Re: Rockfall Protection System Conformance - Revised
5023 KeikilaniCircle
Honolulu, Oahu, Hawaii
TMK 3-6-023:006

Ref: Atlas Geotechnical, 28 April 2015, "Rockfall Hazard Assessment and Mitigation,
5023 KeikilaniCircle, Honolulu, Oahu, Hawaii, TMK 3-6-023:006."

Re: Rockfall Hazard Assessment and Mitigation
5023 Keikilani Circle
Honolulu, Oahu, Hawaii
TMK 3-6-023:006

Site Plan
 Figure 2

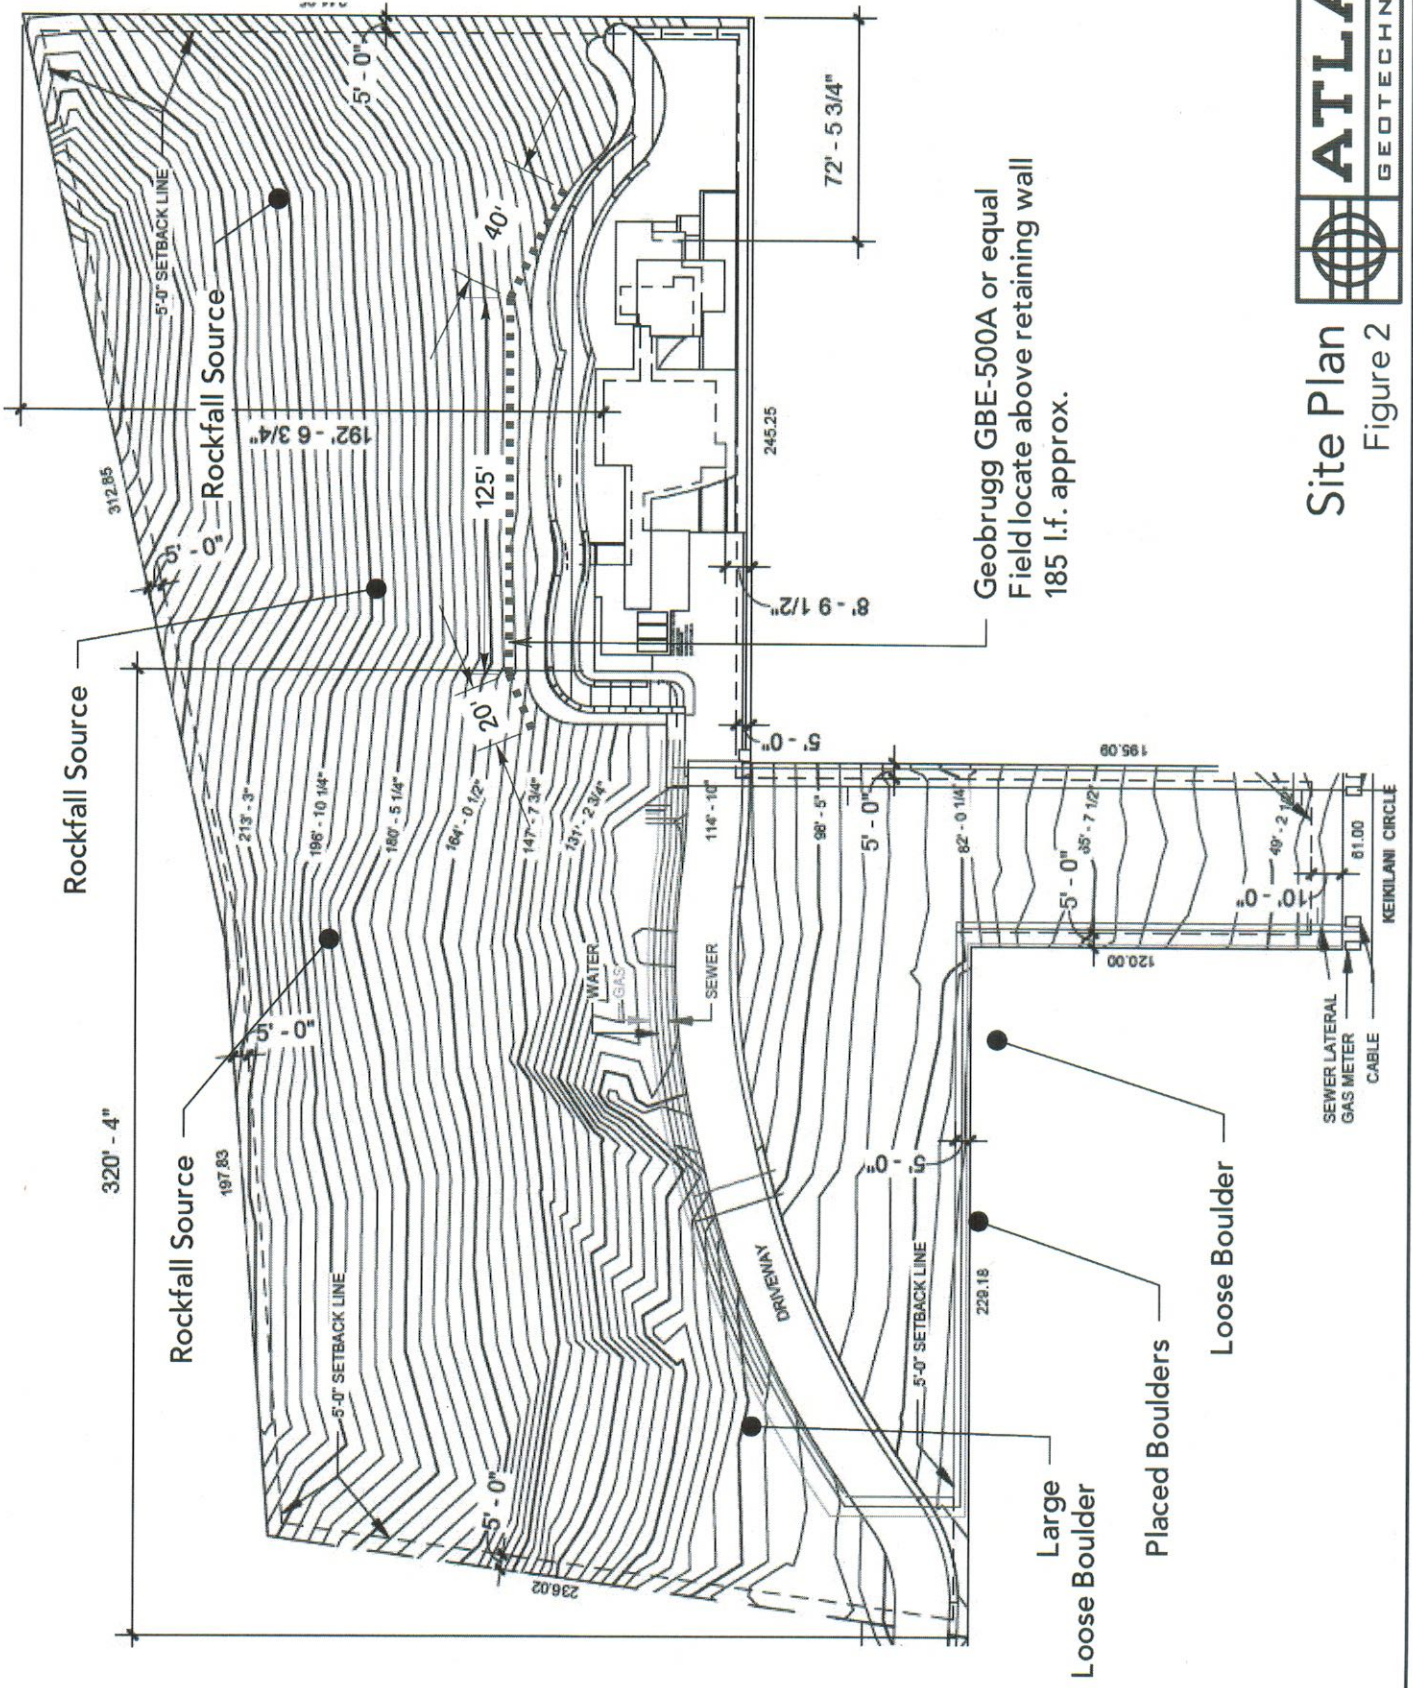
- 3.1. Considering the relatively small scale of the development, we recommend that the fence be continuous across the top of the development.
 - 3.2. Figure 2 shows a conceptual barrier alignment; we recommend that the installation contractor adjust as necessary to suit observed site conditions.

Geobugg GBE-500A or equal
 Field locate above retaining wall
 185 l.f. approx.
